Subject: Draft Combined EIR for the proposed Valley-Ivyglen Subtransmission Line Project and the Alberhill System Project, Riverside County, California

Subject: Office of Ratepayer Advocates Comments on the Draft Environmental Impact Report Issued Regarding the Alberhill System Project and Valley-Ivyglen Project.

Reference: Draft Environmental Impact Report, SCH Nos. 2008011082 and 2010041031, California Public Utilities Commission Proceeding Applications 07-01-031 and 09-09-022.

Figure 3: No Project Alternative

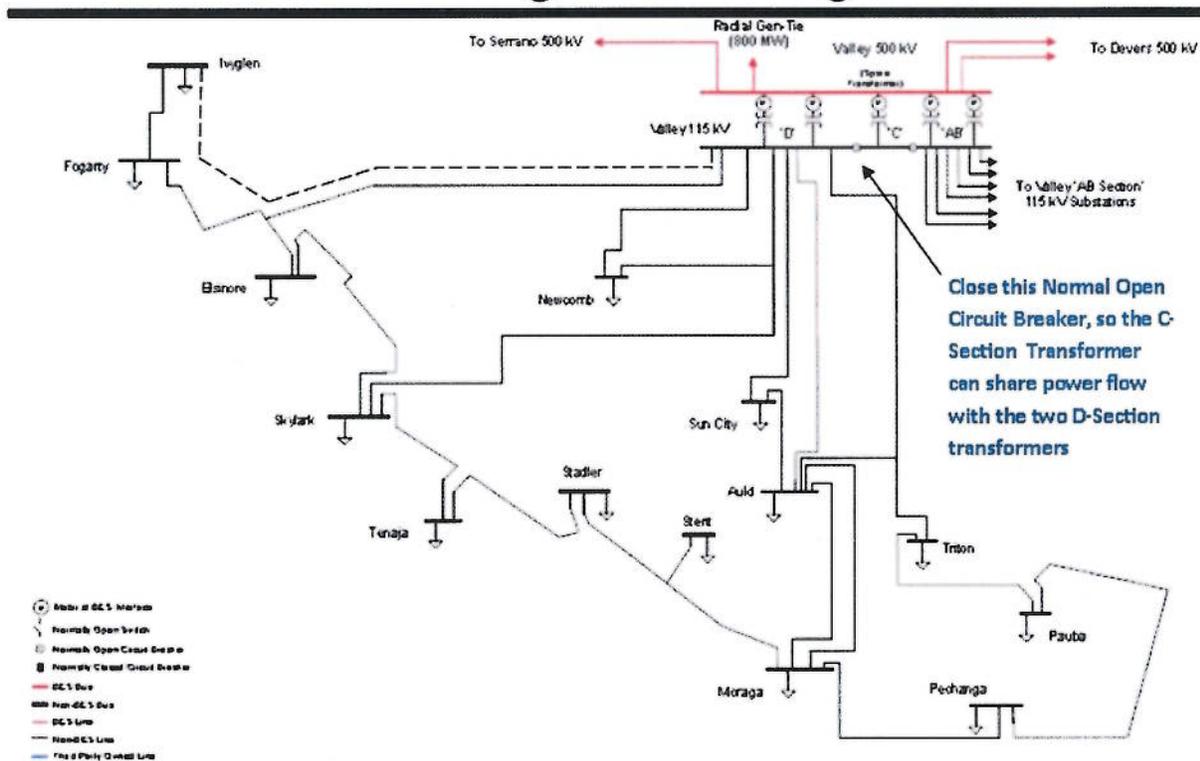
SCE stated that the C-Section transformer at the Valley Substation operates "as a spare transformer ... during emergency or maintenance conditions." Accordingly, SCE currently sets the circuit breaker between the C-Section and the D-Section at "normal open" position. From an electrical prospective, the C-Section transformer is able to mitigate over loading of AB-Section or D-Section transformers. Therefore, ORA proposes that SCE modify its planning approach and operating procedures so that the circuit breaker may be closed when the D-Section transformers are to be overloaded. In parallel with the two D-Section transformers, the C-Section transformer will be able to provide additional power transfer capability and mitigate potential overload conditions on D-Section transformers. Under this approach, SCE is able to elect when to perform

transformer maintenance. This is a No-Project alternative because it includes changes to circuit breaker settings and operating procedures only, with no environmental impact and no additional capital cost.

The DEIR makes a reference to ORA’s recommendation in its No Project Alternative section but only as an “event anticipated with respect to the proposed Alberhill Project” if operation and construction of ASP does not occur¹. Specifically, the DEIR states:

ORA's recommendation is that the Commission fully evaluates this option as a competing alternative.

Figure 4: Divide Valley South System into Two Parts

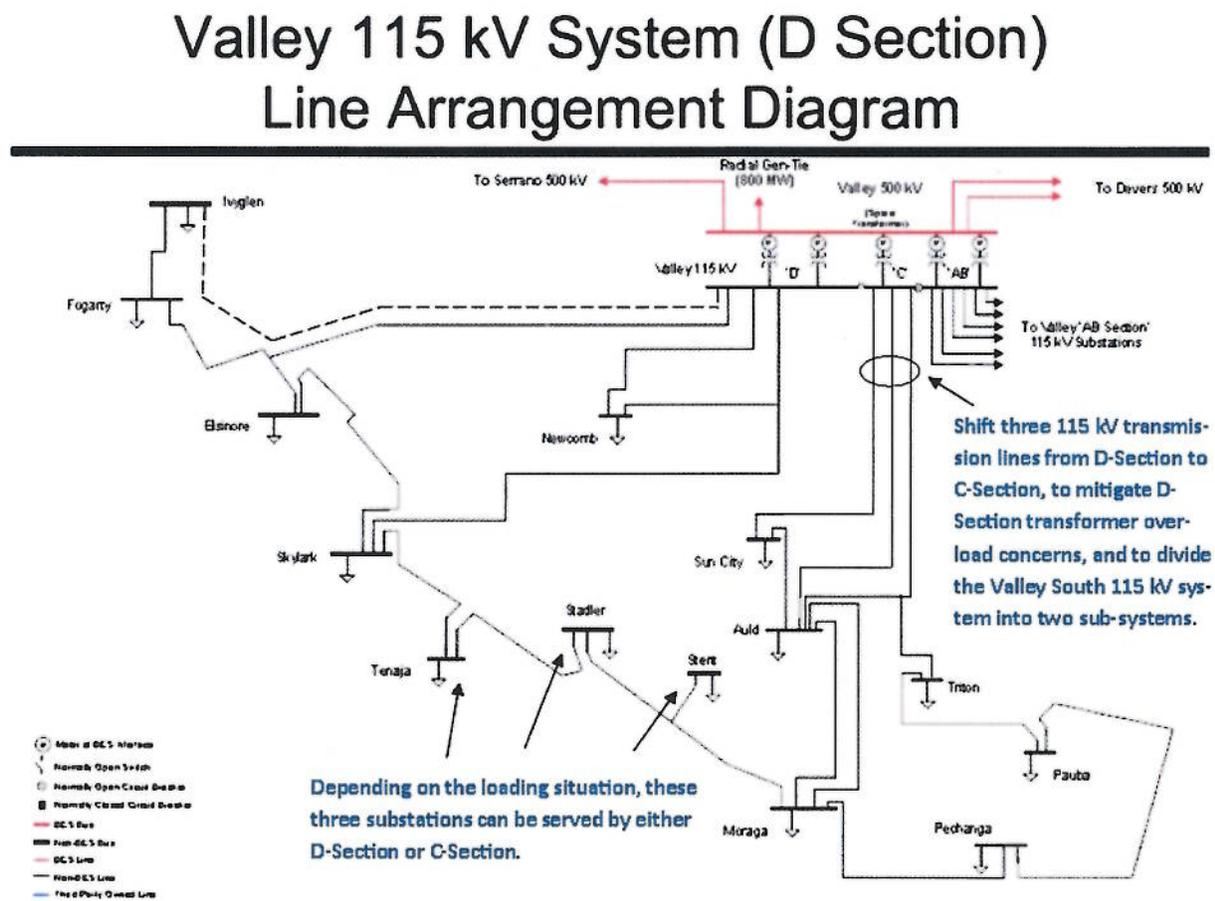
SCE can also divide the Valley South 115 kV system into two systems so that one system is supplied by the D-Section transformers and the other is supplied by the C-Section transformer. (See Figure 4)

Under this alternative, the three 115 kV transmission lines located to the far right of D-Section can be shifted from D-Section to C-Section, so the Valley South 115 kV system is divided into two systems, with one system being served by the D-Section transformers and the other system being served by the C-Section transformer. Depending on the loading situation of the D-Section transformers and the C-Section transformer, SCE could decide whether Tenaja, Stadler, and Sert substations should be served by the D-Section or C-Section. In addition, the transmission lines connecting these three substations can also act as a system tie between the D-Section System and

the C-Section System. Under this arrangement, the three 115 kV sections (AB, C, and D) can coordinate with each other during emergency and maintenance outages.

Figure 5: Install a new 500/115 kV Transformer

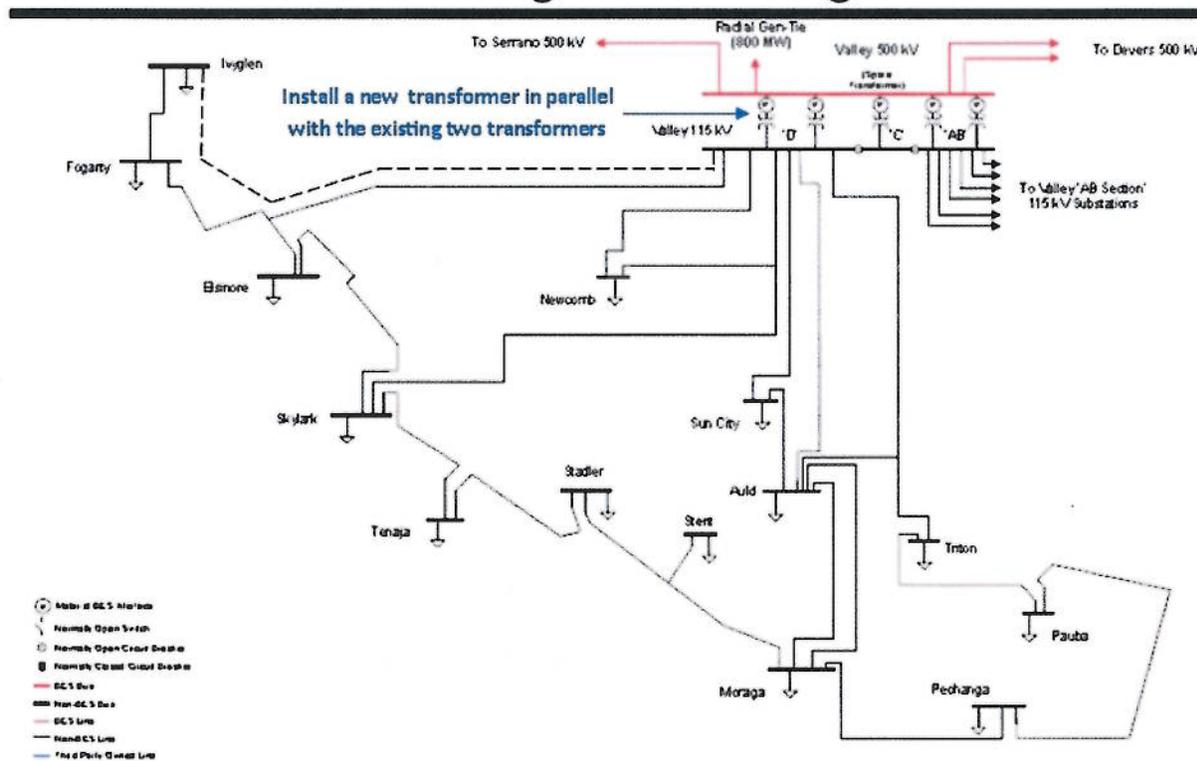
SCE could install a new transformer on the D-Section to mitigate potential transformer overloading under future load growth scenarios. Installing a new transformer would have a lower environmental impact and would cost less than the Proposed Projects. (See Figure 5)

The DEIR stated that “This alternative would relieve projected electrical demand but would not include a new 500/115-kV substation within the ENA [Electric Need Area] or maintain system ties between a new 115-kV system and the Valley South 115-kV System.” The DEIR did not explain why one 500/115kV might be insufficient to service 1,260 square miles and 325,000 customers, did not provide analysis on using the IIEC switchyard as a separate power supply

Figure 6: Reconfigure the Interconnection of the IEEC Power Plant

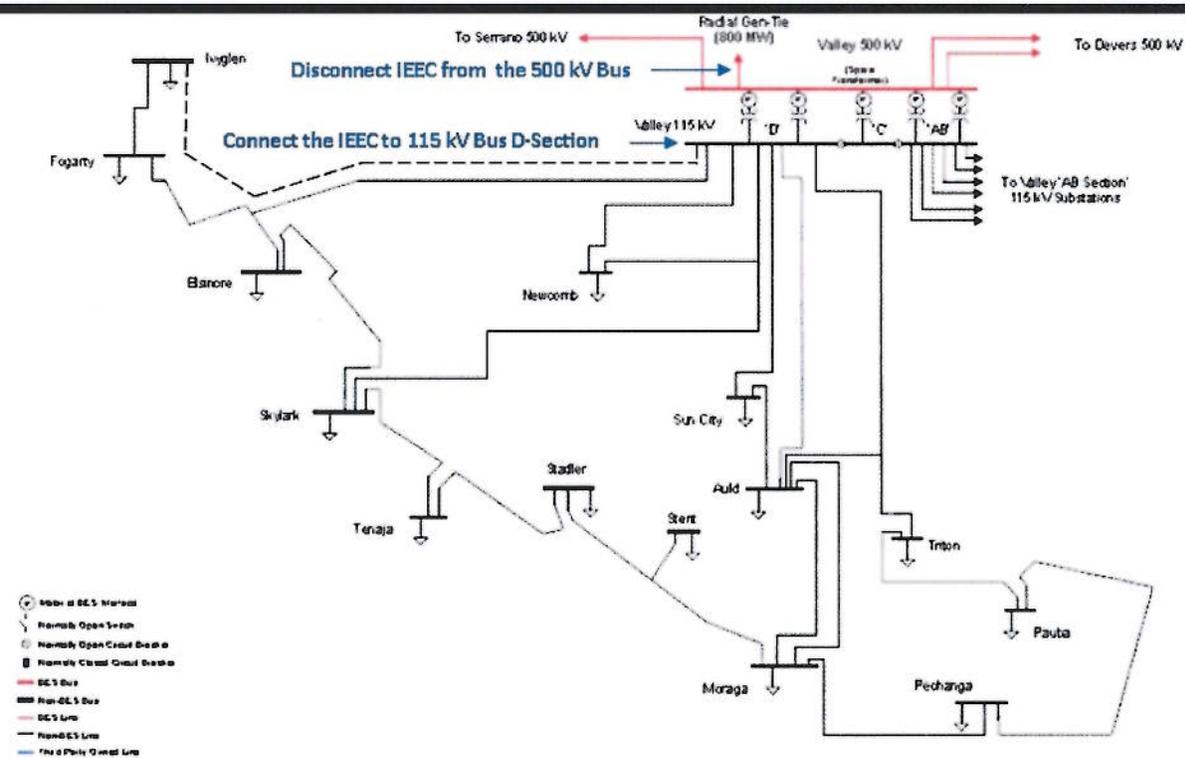
The DEIR stated that “the IEEC interconnection to Valley Substation would require an additional transformer at Valley Substation to step down the electricity generated at the IEEC from 500 to 115 kV.” So the DEIR combined the Additional Valley South Transformer Alternative with the IEEC Interconnection Alternative.⁴ ORA’s analysis concludes that it does not make engineering sense to step up the IEEC power to 500 kV and then to step down to 115 kV to serve local demand.

ORA proposes to step up the IEEC generation output to 115 kV and to interconnect the IEEC power plant directly to the Valley 115 kV D-Section. With this alternative, the power flow on the 500 kV bus and the two D-Section transformers would be significantly reduced, so there would be no overloading issues and no need to install another 500/115 kV transformer at Valley Substation. This reconfiguration would also have additional benefit of reducing transmission losses, because the power would not need to be stepped-up and stepped-down through those transformers before it is delivered to the Valley South area. This alternative would have a lower environmental impact and would be less capital-intensive than the Proposed Projects. (See Figure 6 below)

Figure 7: Loop in Talega—Escondido 230 kV Line to Upgraded Moraga

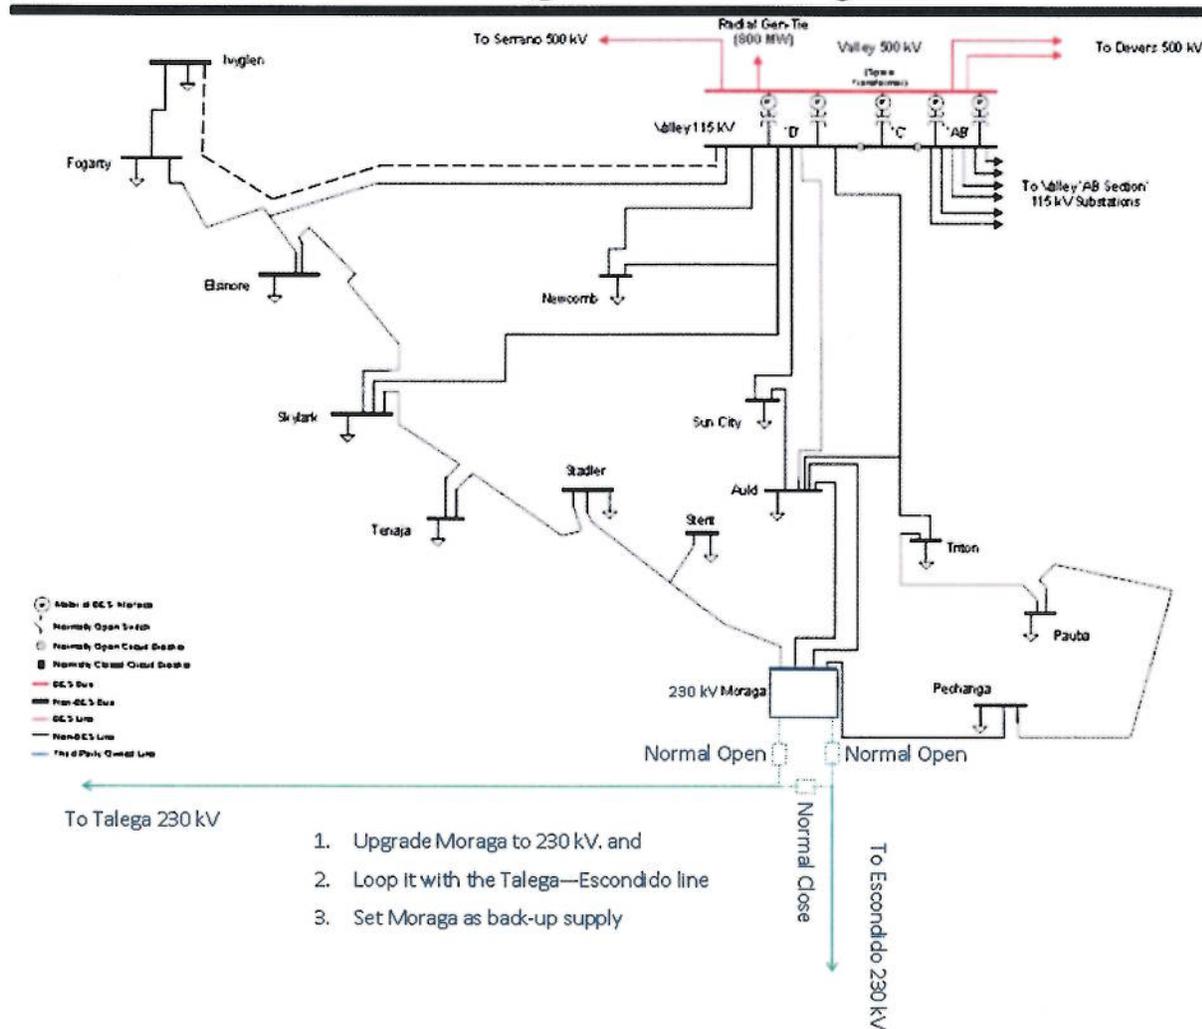
ORA believes that SCE could also upgrade the Moraga Substation to 230 kV, then loop it with SDG&E's Escondido—Talega 230 kV transmission line at Interstate 15. Such a loop-in would reduce the power flow on Valley Substation D-Section transformers and provide power supply flexibility and reliability to the Valley South area. This approach is similar to that for the Valley

North area, which uses the 220kV Vista Substation as back up supply to the Valley North area when Valley AB-Section is not available. ORA's initial review indicates that new 230 kV transmission lines needed to loop in the Moraga Substation would be approximately 5.5 miles long. There are four 115 kV transmission lines from the Moraga Substation to serve other substations within the Valley South area. Compared to the Proposed Projects, this alternative will be environmentally superior and more economical because this alternative would eliminate the 500 kV Alberhill Substation, the approximately 3.3 miles of 500 kV double circuit transmission line to loop in the Alberhill Substation, and other modified and new 115 kV transmission lines.
